Accessibility Survey

Adris Avenue - Angell Street To Foster Road

Date of Inspection
12/3/2016

Disability Access Consultants

Change in Level North of Ratliffe Street @ 33.913934145781, -118.129901736975

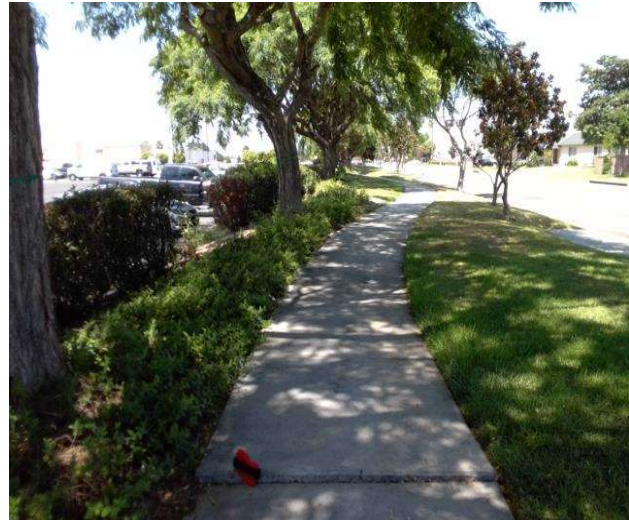
There is a change in elevation greater than recommended value.

On-Site Finding 1.75 inches

Ensure that the change in elevation is within the recommended value.

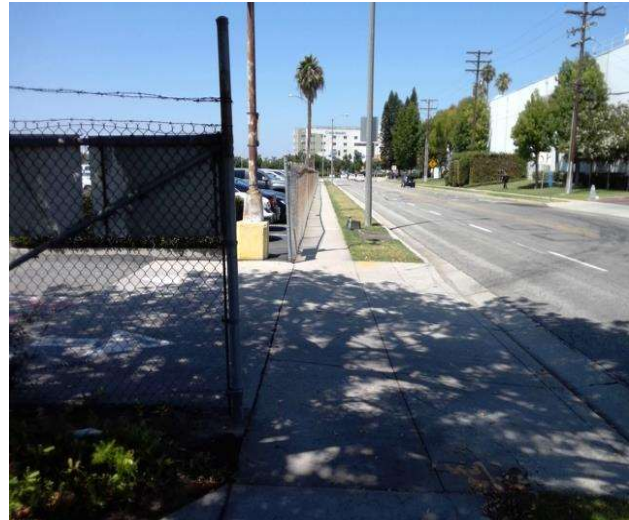
There are no detectable warnings where the pedestrian route crosses vehicular traffic.

On-Site Finding Not Found

Provide detectable warnings.

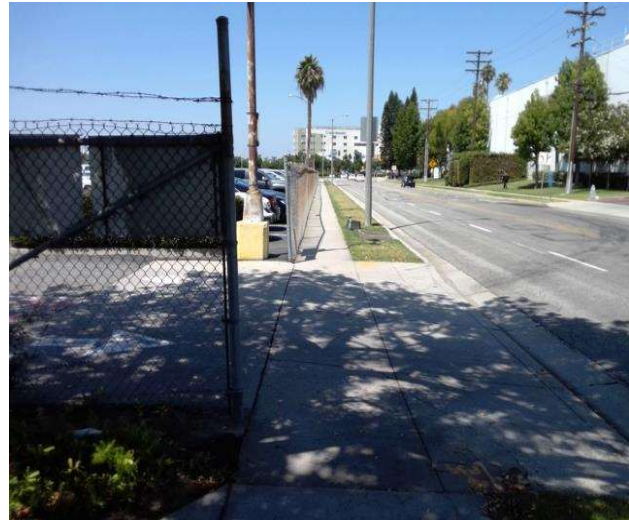
Cross slope at vehicular traffic is not compliant.

On-Site Finding 9.60 percent

Repave the surface to provide a compliant cross slope.

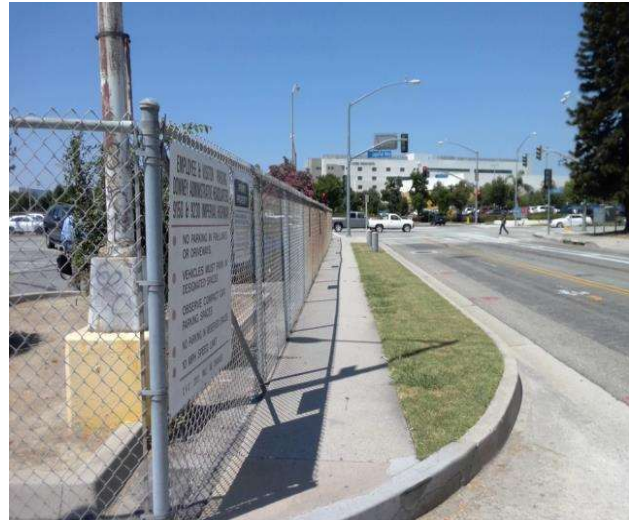
Sidewalk cross slope is not compliant.

On-Site Finding 3.20 percent for 132.00 feet

Repave the sidewalk surface with the recommended cross slope.

Change in Level North of Ratliffe Street @ 33.913934145781, -118.129901736975

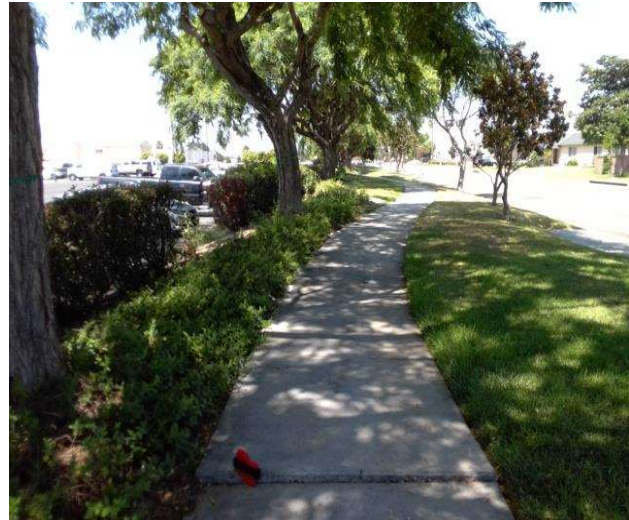
There is a change in elevation greater than recommended value.

On-Site Finding 1.75 inches

Ensure that the change in elevation is within the recommended value.

Change in Level North of Ratliffe Street @ 33.916135534967, -118.129861503839

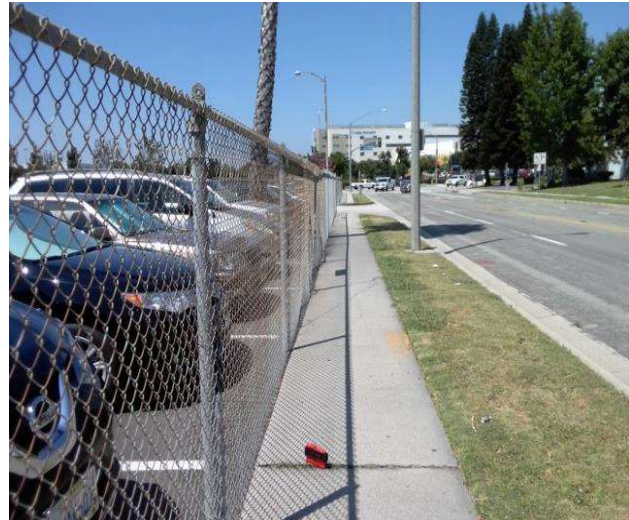
There is a change in elevation greater than recommended value.

On-Site Finding 0.50 inches

Ensure that the change in elevation is within the recommended value.

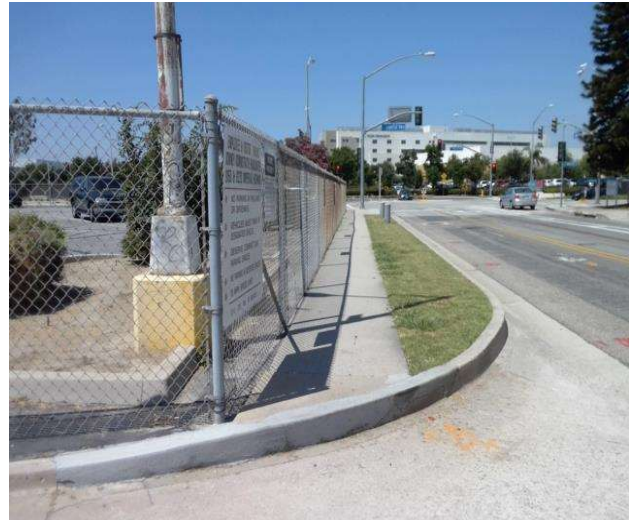
There is a curb on the designated path of travel.

On-Site Finding Not Compliant

Provide a compliant curb ramp.

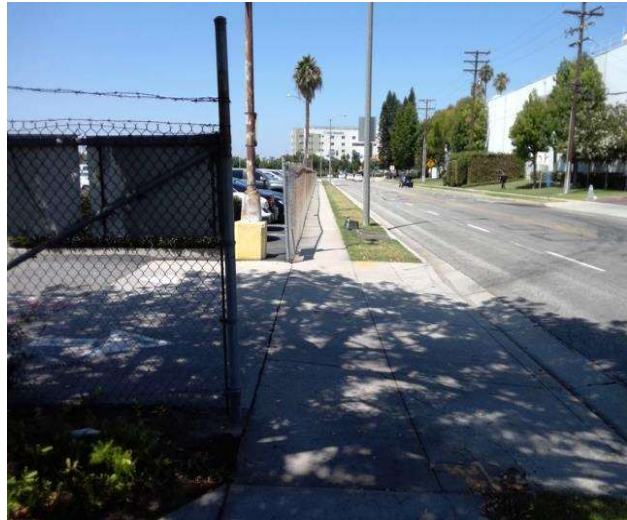
Cross slope at vehicular traffic is not compliant.

On-Site Finding 9.60 percent

Repave the surface to provide a compliant cross slope.

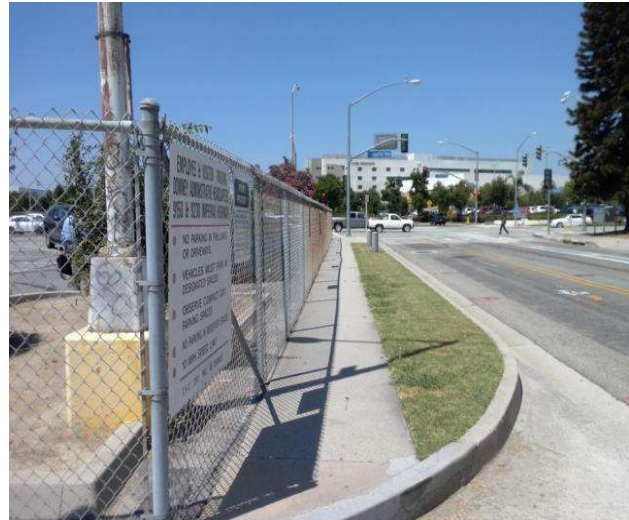
Sidewalk cross slope is not compliant.

On-Site Finding 3.20 percent for 132.00 feet

Repave the sidewalk surface with the recommended cross slope.
